RE: Design Changes to WG31B1 and WG41B1
A&B Matter No. 048546/387545

The purpose of this memorandum is to advise you of certain design changes that have been proposed for the model WG31B1 and WG41B1 beta ray sensor for which a draft of the Sealed Source and Device registration certificate has been issued by the Georgia Department of Natural Resources, Radioactive Materials Program (“Agency”).

Figure 1. Current design of buttons and switches on b-stand.

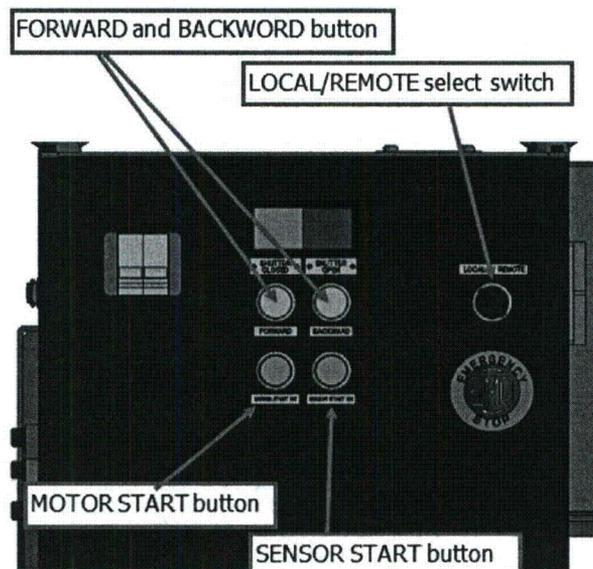
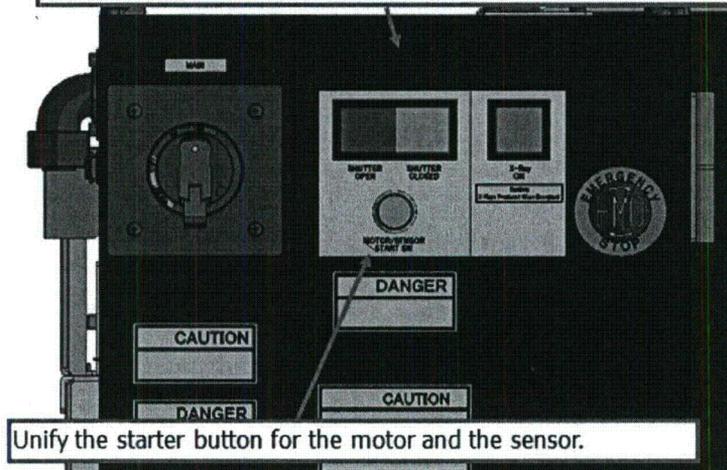
As illustrated in Figures 1 and 2, the FORWARD and BACKWARD buttons that manually control the movement of the sensor along the stand and the LOCAL/REMOTE button that selects whether the sensor is controlled locally or via a remote station have been relocated to inside the b-stand to prevent the possibility of activation from outside the stand.

Relocate the LOCAL/REMOTE switch and the FORWARD and BACKWARD buttons to inside the stand to prevent operating outside the stand.

Also, we propose merging the motor and sensor start operations into one button. Activation of the button will cause power to be supplied to the motor for moving the sensor across the frame and to the sensor enabling the sensor to start.

Figure 4. Proposed design of buttons and switches on f-stand.

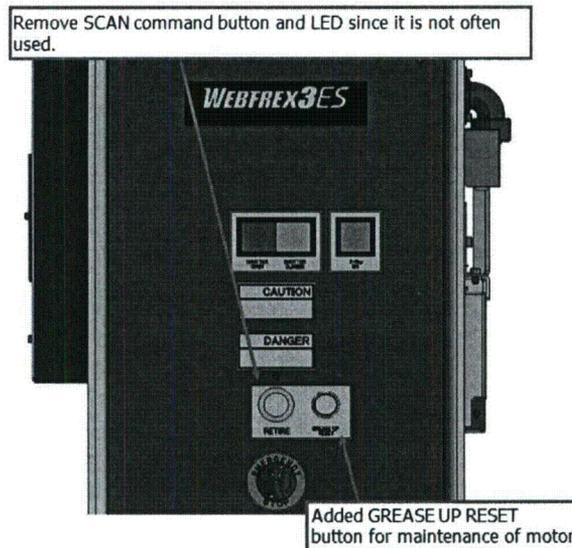
As illustrated in Figures 3 and 4, the SCAN command button has been removed from the f-stand. Under this revision, the sensor cannot be placed into SCAN mode from the f-stand. Rather, the sensor may be placed into SCAN mode only by executing the SCAN command from the remote station or through some other external signal input.

Additionally, a GREASE UP RESET button has been added to reset the clock for counting down the time for when the main shaft bearings require greasing.

Figure 5. Current design with keyswitches for bypassing interlocks without covers.

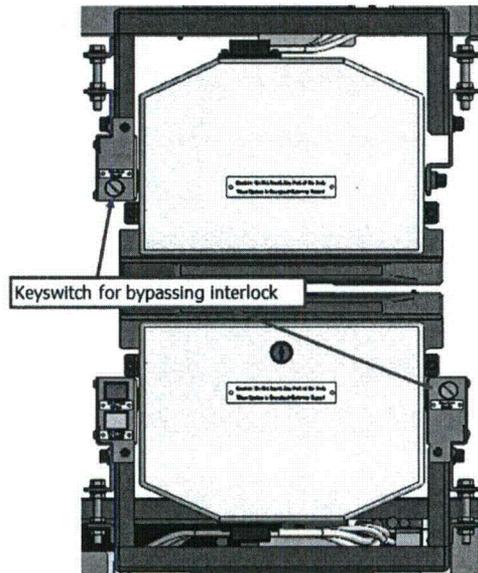
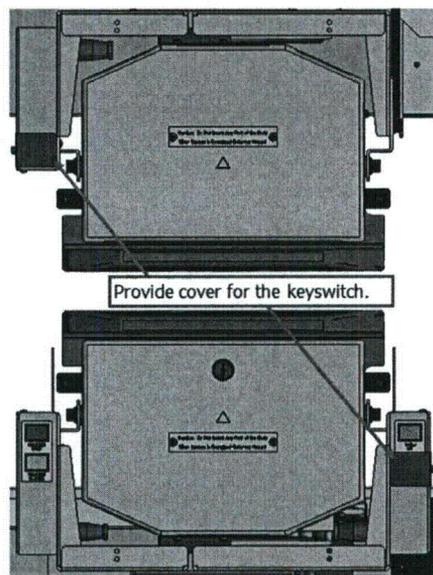
As shown in Figures 5 and 6, the keyswitches for bypassing the interlocks that disable power to the unit forcing the shutter to the closed position in the event a cover is lifted have been provided with covers.

Figure 7. Current design of method for locking b-stand cover.

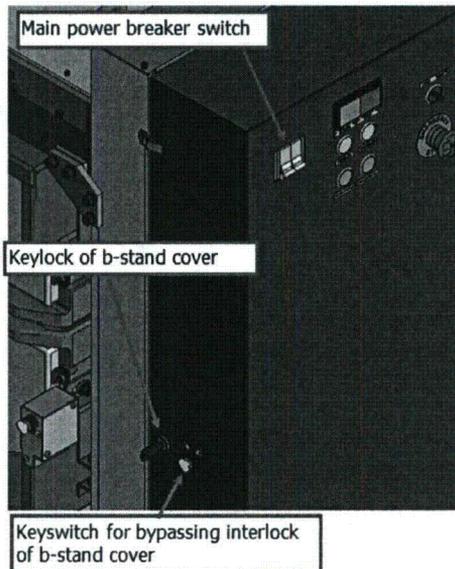
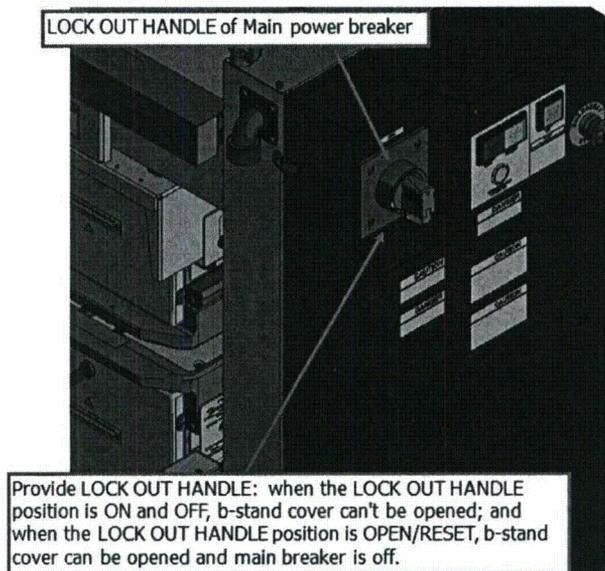
Figures 7 and 8 illustrate the current and proposed designs for locking the b-stand cover. Currently, the b-stand is equipped with a keylock for locking the cover and a keyswitch for bypassing the interlock. In the event the b-stand cover is opened, the interlock disables the main power so that access into the b-stand is safe and the shutter is forced to the closed position.

Figure 9. Mechanical design and operation of proposed lockout handle.

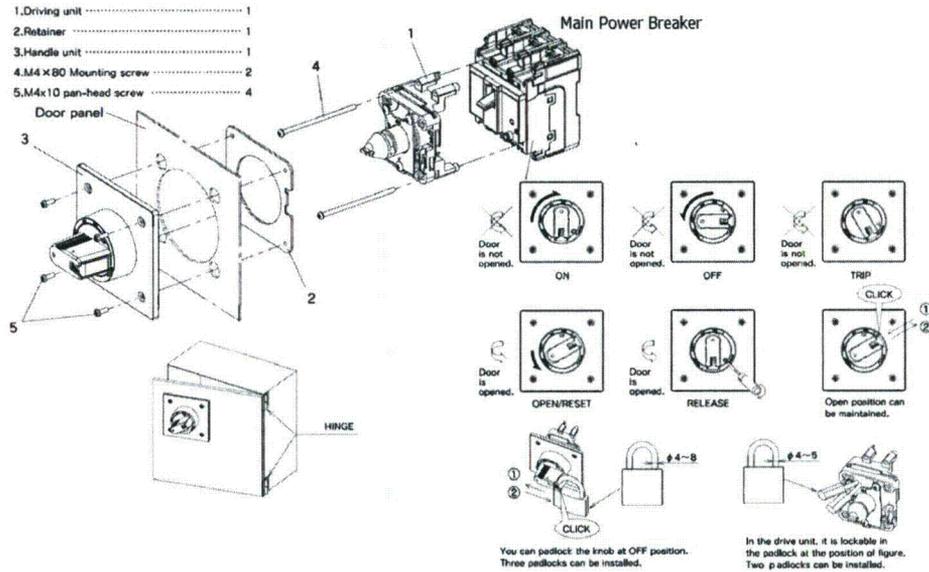
The mechanical detail for and the operation of the proposed lockout handle on the b-stand cover is provided in Figure 9. According to the proposed design, the keylock and keyswitch have been replaced with a lock out handle for the main power breaker. If the lock out handle is in the ON or the OFF position, the b-stand cover cannot be opened. However, if the lock out handle is set to the OPEN/RESET position, then the b-stand cover can be opened and the main breaker is set to OFF.

Figure 10. Current design showing attachment of labels using M3 screws.

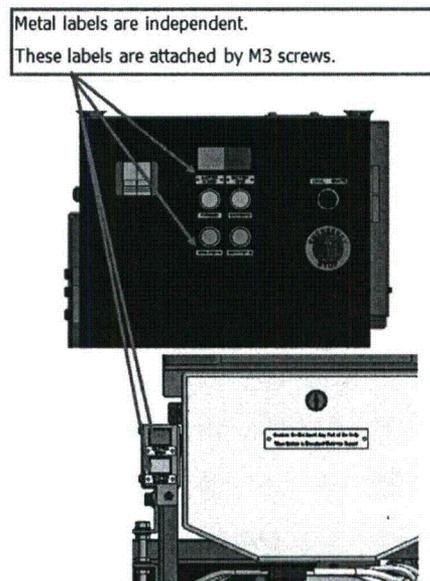
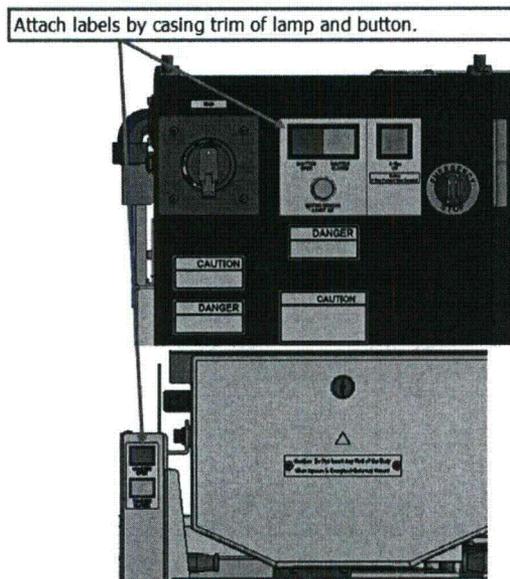
As shown in Figure 10, labels are currently affixed by the use of M3 screws. As shown in Figure 11, it is now proposed that the labels for lamps and buttons will be attached by the use of the casing trim of the lamp and/or button.

Figure 12. Mechanical detail showing how the casing trim is affixed to the device.

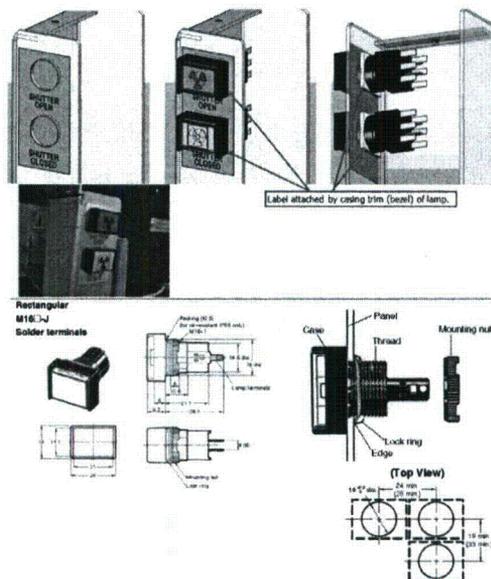
Figure 12 provides the mechanical detail for how the casing trim of the lamps and buttons are affixed to the device.

Figure 13. Current design of brackets and lamp and key boxes.

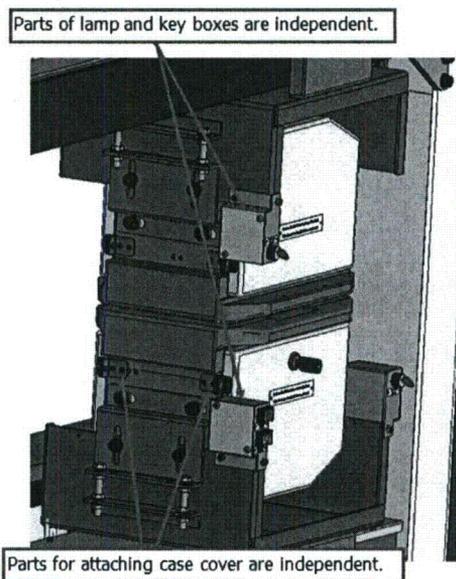
As shown in Figure 13, the covers are affixed to the sensor case using independent brackets. As shown in Figure 14, the proposed design adopts a uniform bracket to which the covers will become affixed.

It is proposed that a more streamlined design of the lamp and key boxes be adopted. The new streamlined box design has a more integrated design that is better situated in the overall footprint of the device. The new design also simplifies access to the box when needed for component replacement.

Figures 13 and 14 highlight the differences between the design of the current boxes and the proposed streamline design, respectively.
